Lexington Planning Board

Wednesday, May 8, 2024

28 Meriam St. & 32 Edgewood Rd., 28 Meriam Street Lexington, LLC – Site Plan Review
Public Hearing for special residential development (continued from March 13 & April 11)

Date May 2, 2024
To Abby McCabe, Planning Director
From Thomas C. Houston, PE, AICP
Project Application for Major Site Plan Review for
Special Residential Development (Site Sensitive)
28 Meriam Street & 32 Edgewood Road
Lexington, Massachusetts
Subject Evaluation of Responses to Peer Review Comments and the Third
Submission to the Planning Board

Use this table to calculate your Average Natural Grade. **BUILDING B**

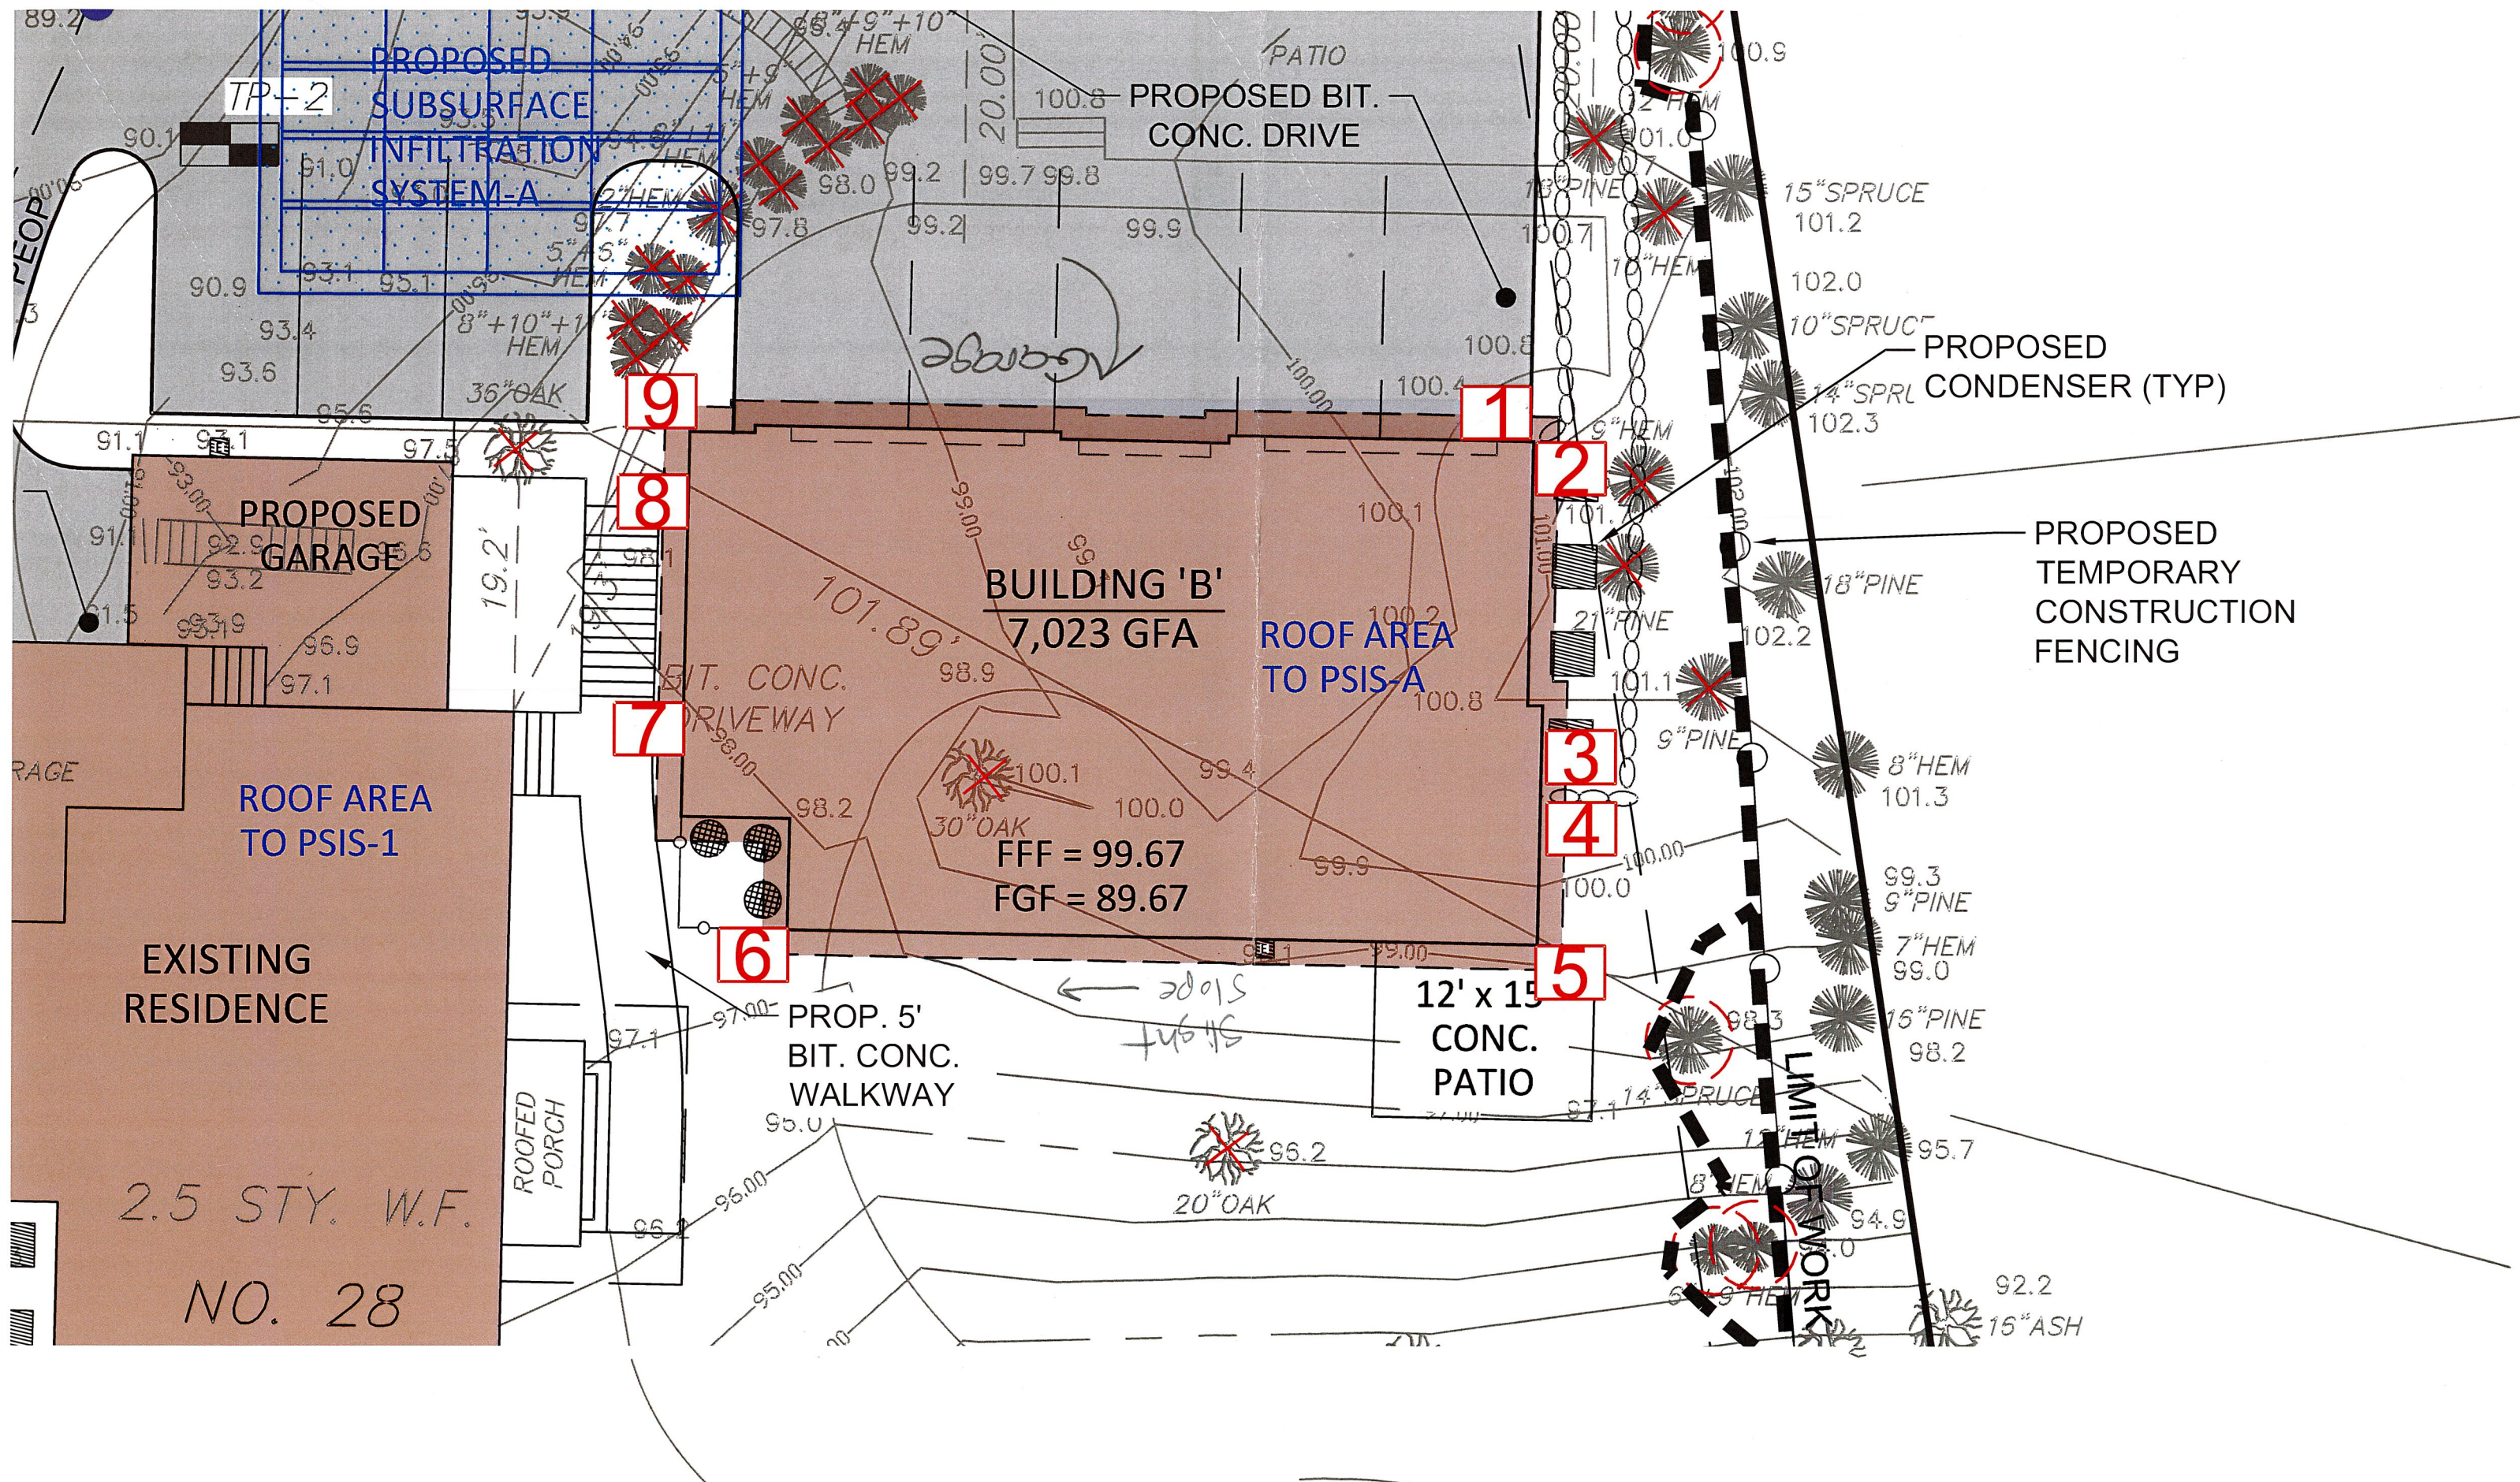
explain elevations between 7 + 8, I see stairs before #6

whats FGF

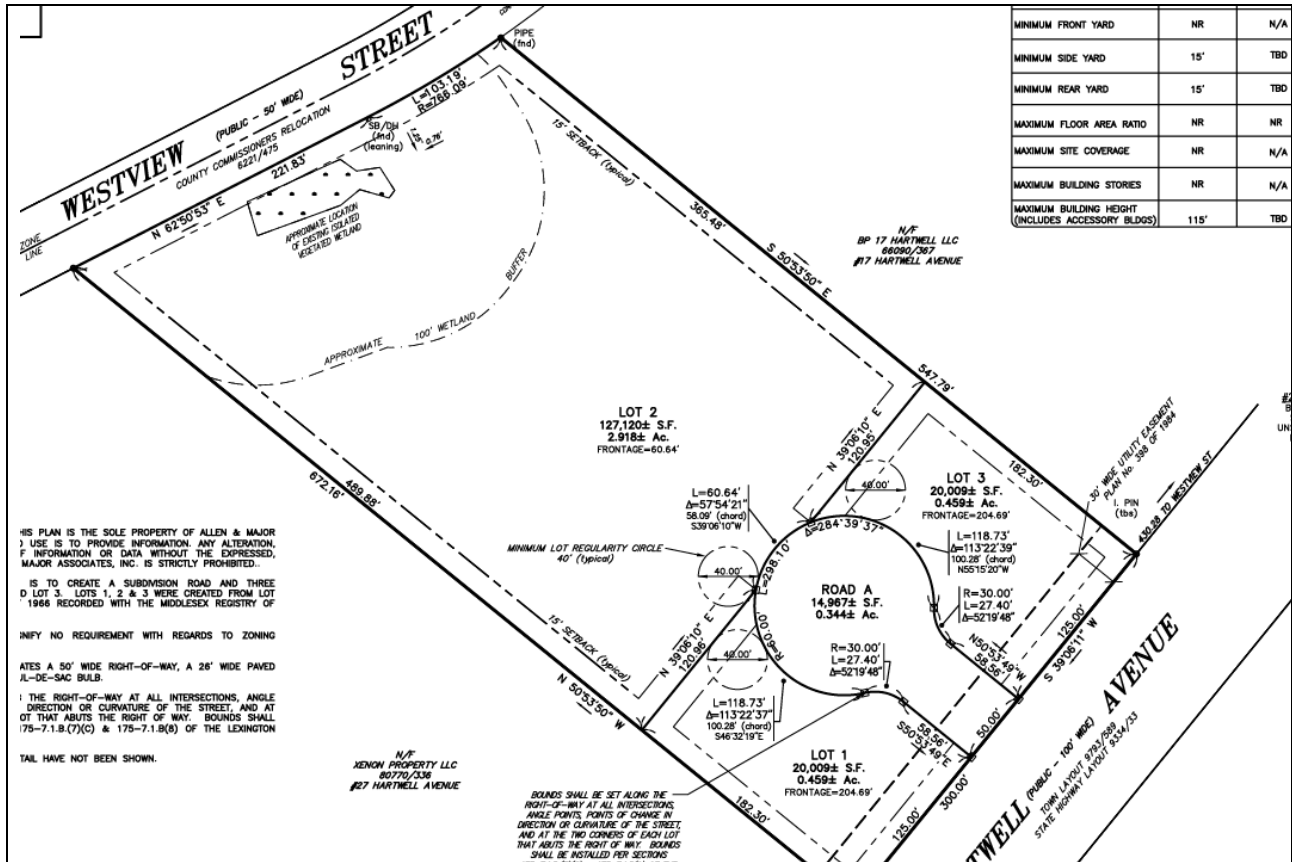
- The Fire Truck Turning Plan analyzed the access capabilities of a 39-foot long truck. The overall length of Ladder 1 is 42-feet 3-inches, which includes the overhang of the ladder. The plan should be revised to analyze the length of Ladder 1.
- The turning radius needs to allow the ladder to make the turn without the overhang crossing the curb, in the case of trees, signs, and/or light-posts being placed along the roadway.
- The applicant needs to use an Inside Cramp Angle of 45.
